RE: **Shawn McWethy Park – Phase 2A**
Grading Plan
Engineer's Stamp Date: 10/10/17
Hydrology File: J09D023A

Based upon the information provided in the submittal received on 10/11/17 the above-referenced Grading Plan is approved for Grading and Paving Permit.

Re: Shawn McWethy Park – Phase 2A, J09D023A Hydrology Resubmittal

SHAWN MCWETHY PARK PHASE 2A
GRADING PLAN

LG101

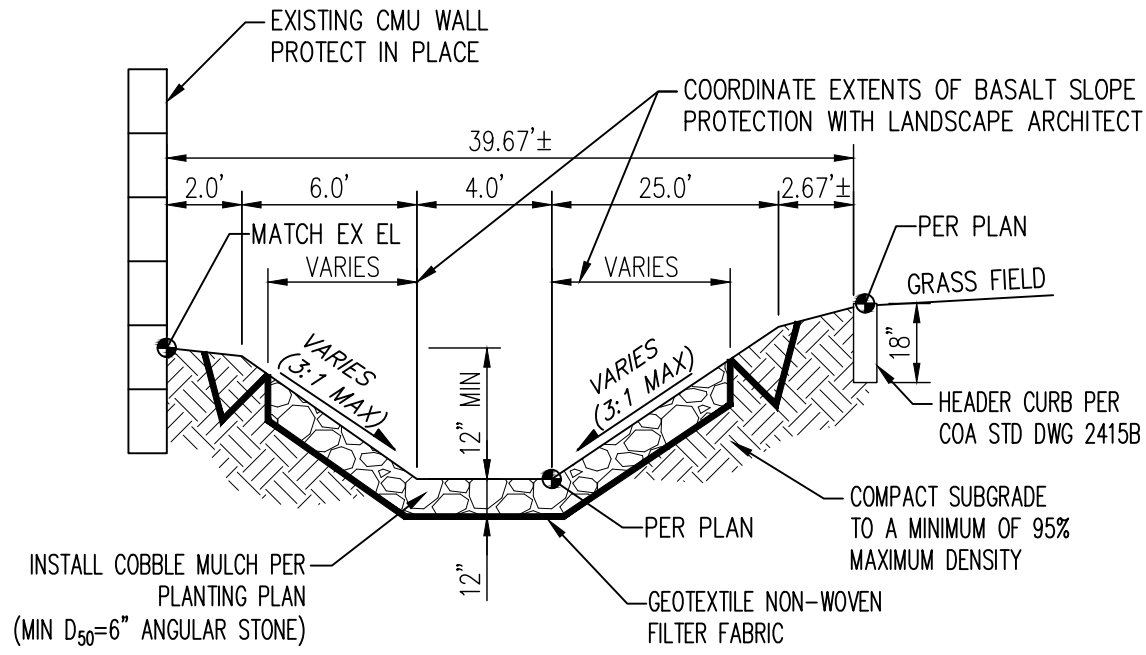
1. The Grading Plans are now stamped.
2. Benchmark and elevation data are now included.
3. The west side desilting swale now includes an armored weir spillway. Calculations for the temporary weir are included as well.
4. The MWSE is now shown.
